Project	<b>IEEE 802.16 Broadband Wireless Access Working Group</b> < <a href="http://ieee802.org/16">http://ieee802.org/16</a> >	
Title	<b>Clarification of H-ARQ Operation with Reduced AAS Private Map</b>	
Date Submitted	<b>2005-01-11</b>	
Source(s)	Inseok Hwang ,Jaehee Cho, Seungjoo Maeng, Jaeho Jeon, Soonyoung Yoon, Samsung Electronics Co. Ltd.	<a href="mailto:is91.hwang@samsung.com">is91.hwang@samsung.com</a>
Re:	Recirculation of P802.16 REVe/D5a	
Abstract	Some clarification and modification of Reduced AAS private map is proposed for reliable H-ARQ operation.	
Purpose	Adoption of suggested changes into P802.16e/D6	
Notice	This document has been prepared to assist IEEE 802.16. It is offered as a basis for discussion and is not binding on the contributing individual(s) or organization(s). The material in this document is subject to change in form and content after further study. The contributor(s) reserve(s) the right to add, amend or withdraw material contained herein.

Fig. 1. Reduced AAS Private MAP Operation

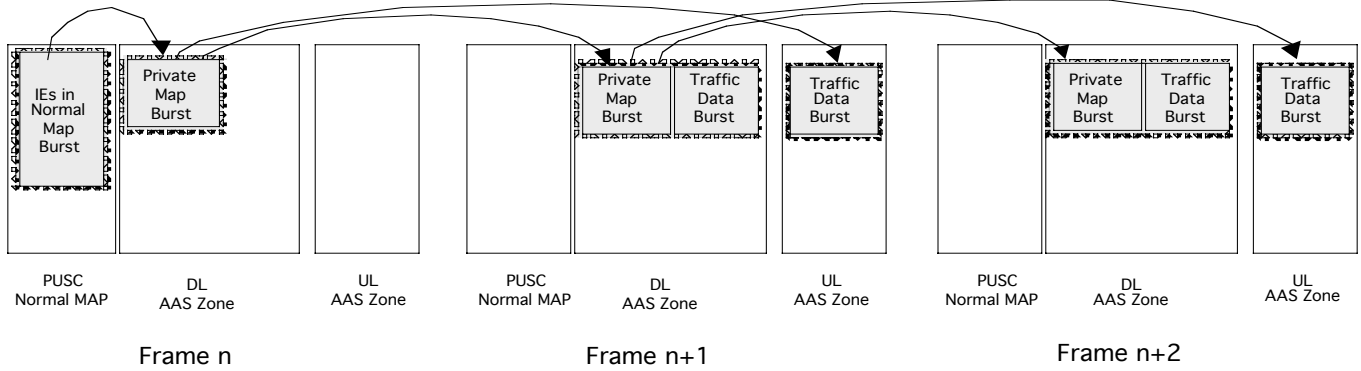
The reduced AAS private map concatenates MAP and DL data burst and apply the coding and modulation to the concatenated burst, which is designed to exploit beam-forming gain and signaling efficiency of bandwidth allocation. However, clarification and modification of reduced AAS private DL map is needed for reliable H-ARQ operation and MAP signaling. The H-ARQ operation allows the retransmission of coded symbols, which imply that each transmission cannot be decoded correctly. Consequently, the reduced AAS\_private\_map containing H-ARQ signaling information should be encoded separately from DL traffic burst itself to exploit the advantage of H-ARQ operation.

Fig. 1 illustrates the reduced AAS Private MAP operation when reduced AAS Private MAP points the allocation region for next frame. In the figure, dashed box denotes the absolute allocation region and (n+1)<sup>th</sup> frame.

To enable separate modulation and coding, the following fields are added in Reduced\_AAS\_Private\_DL\_MAP message. Note that when ‘Separate MCS Enabled’, DL data burst a reduced\_AAS\_Private\_MAP including all AAS configuration change information, bandwidth allocation, H-ARQ signaling information are encoded separately.

- ‘Separate MCS Enabled’ to indicate separate coding for reduced AAS Private Map and DL data burst
- ‘Slot Duration’ to specify number of slots for transmitting reduced AAS\_Private\_MAP
- ‘DIUC and Repetition Coding Indication’ for reduced AAS\_Private\_MAP

Since the reduced AAS\_Private\_DL\_MAP specifies the two-dimensional region for reduced AAS\_Private\_MAP and DL data burst, the data burst are transmitted through the remaining slots after assigning slots for reduced AAS\_Private\_MAP.
